2NSW-112 (sheet 1 of 2)  
Lower Containment Ventilation  
Unit 1 Supply Line

LIVSEY & COMPANY, INC. INDIANA & MICHIGAN ELECTRIC CO. DONALD C. COOK NUCLEAR PLANT

CRD: LdB DATE: 9/1/70 DWG. NO. 2-NSW-112 SH. 1 of 2

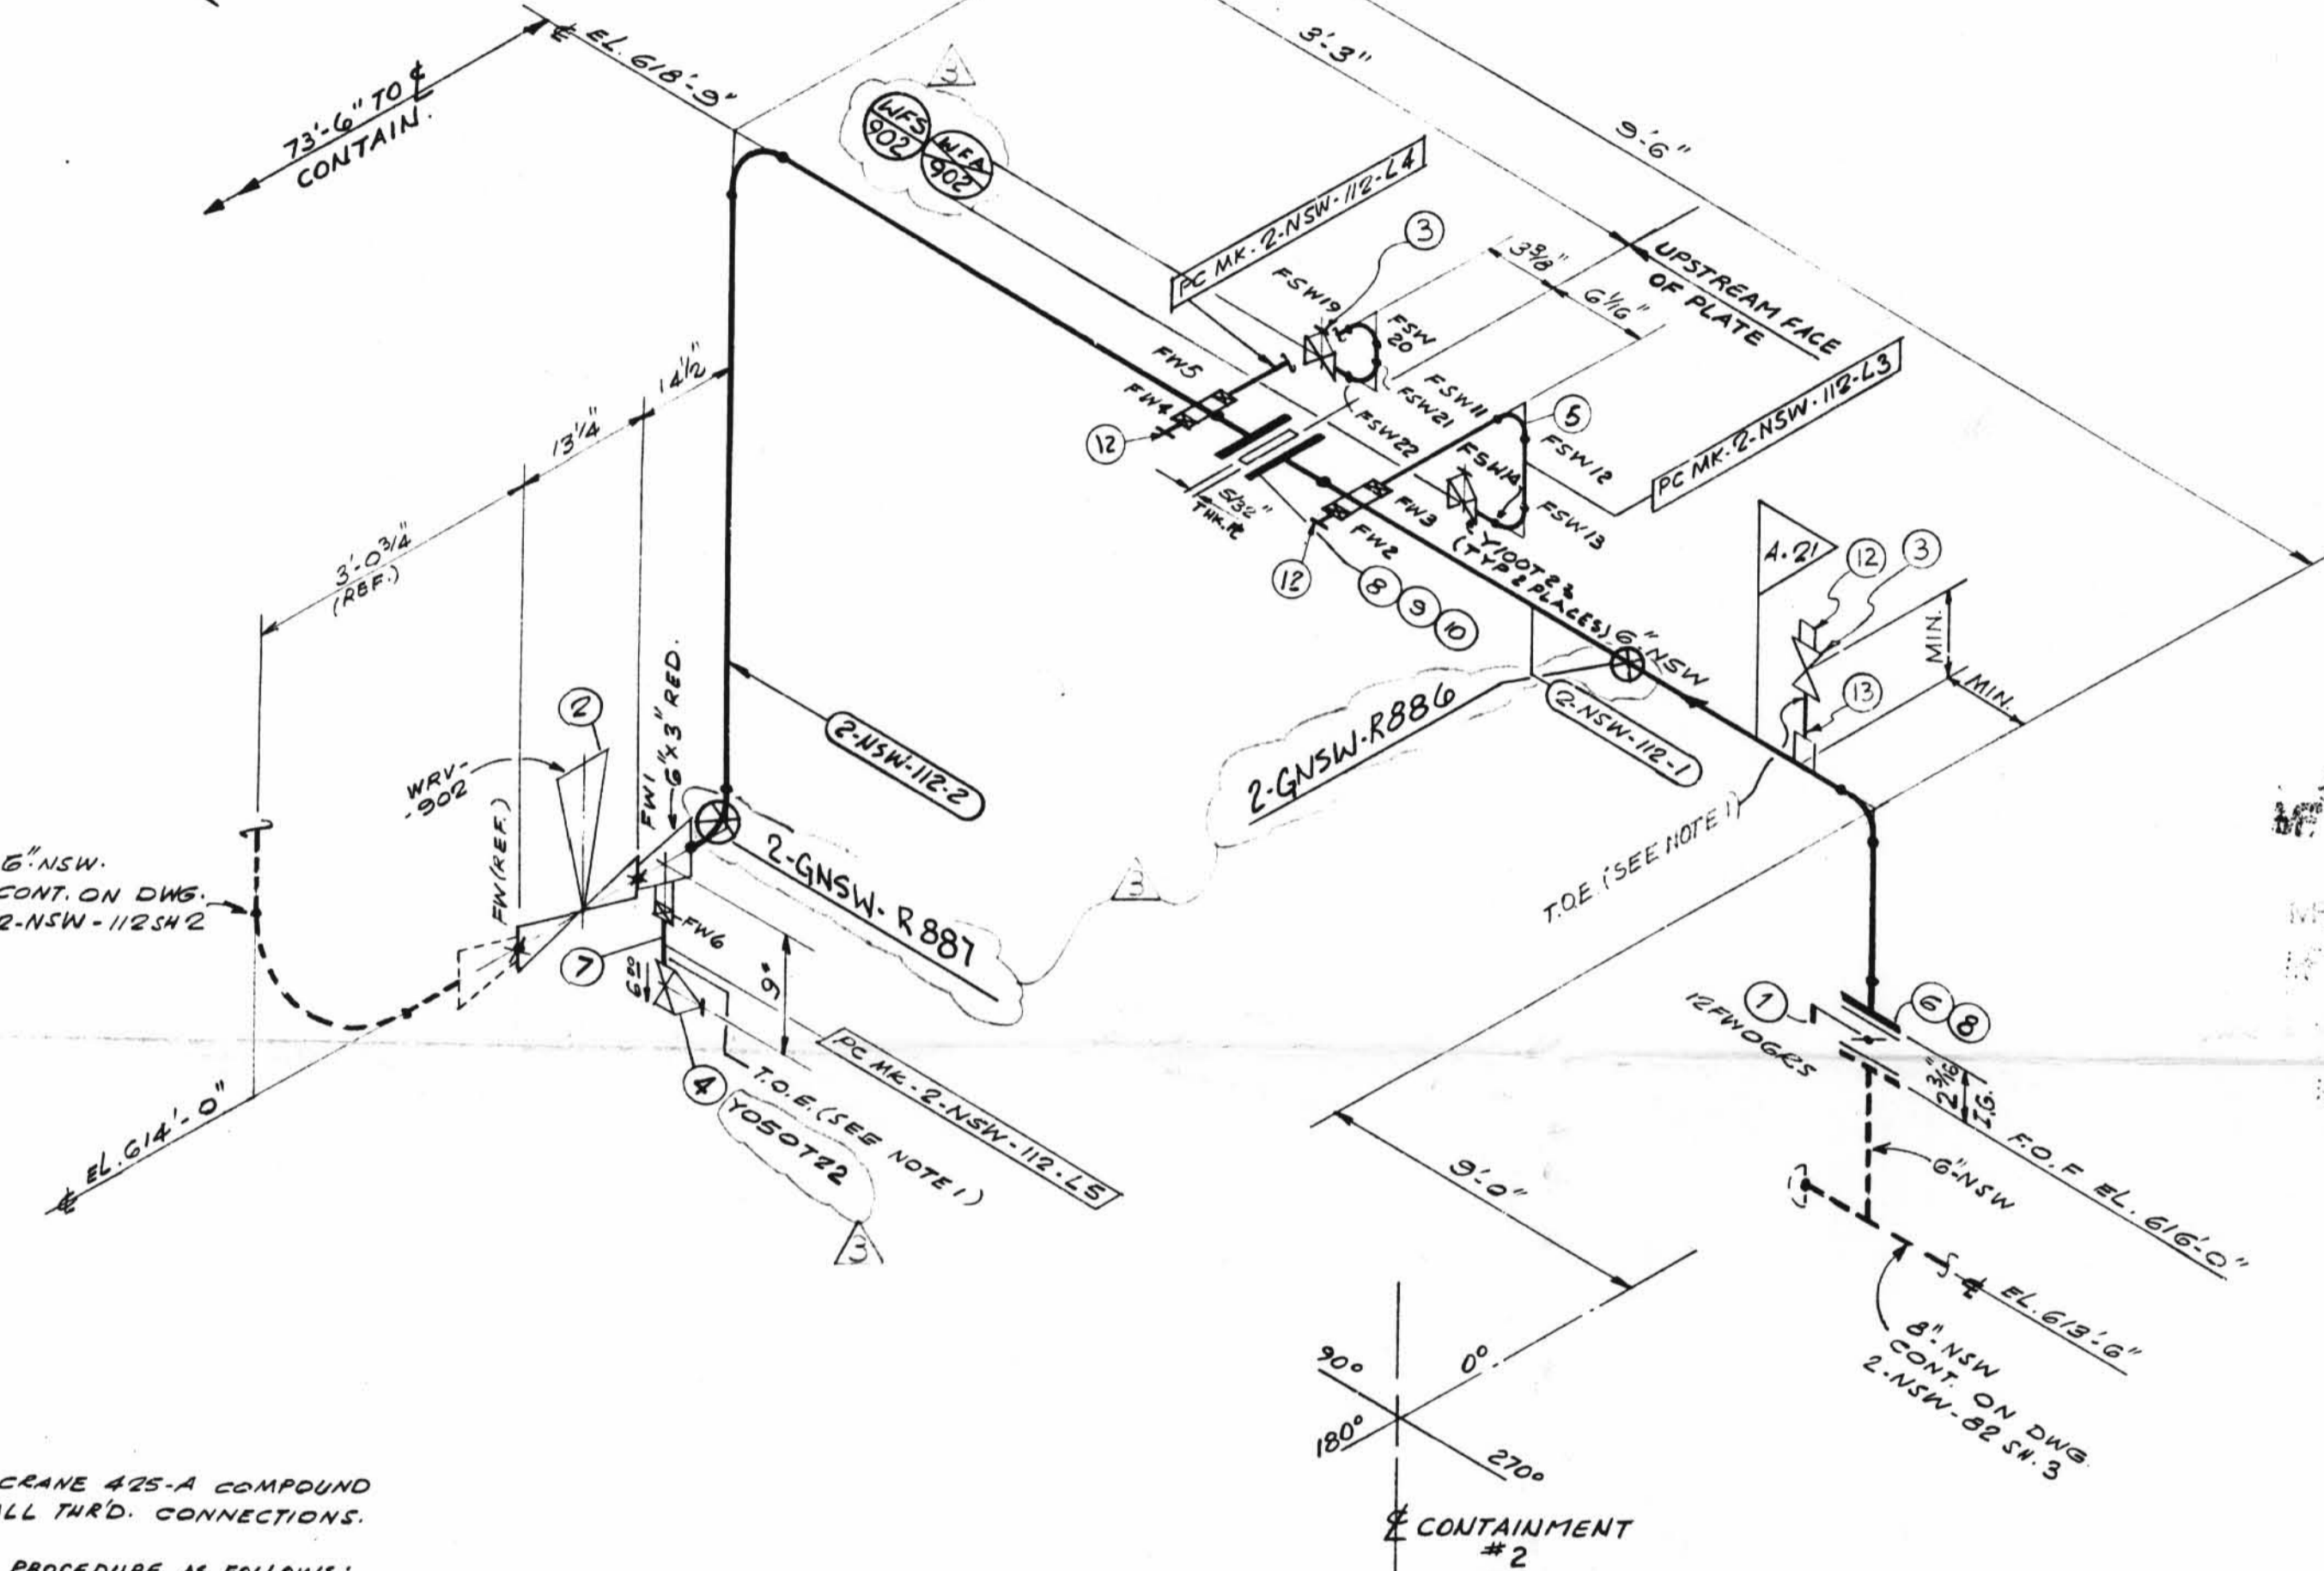
REVISION RECORD				
NO.	DATE	BY	DESCRIPTION	REMARKS
1	8/13/70	FA/LB	REVISED BY AEP. DELETED PIECES 2-NSW-112-L1 & 2-NSW-112-L2 ADDED ITEM 12 IN B/M.	
2	11-30-70	W.R.	ADDED 1" VENT & ADDED ITEM 13; REVISED ITEMS 3 & 12 OF B/M.	
3	9/1/70	DK	PER RFC-DC-12-7876 REV'D INST'S & ITEM 4 VALVE TYPE. ADDED SUPPORT DETAILS. SUPERSEDED HGR 150 2GNSW-112 SHT. ALL ABOVE TO REFLECT AS-BUILT CONDITIONS.	No FIELD ACTION REQ'D
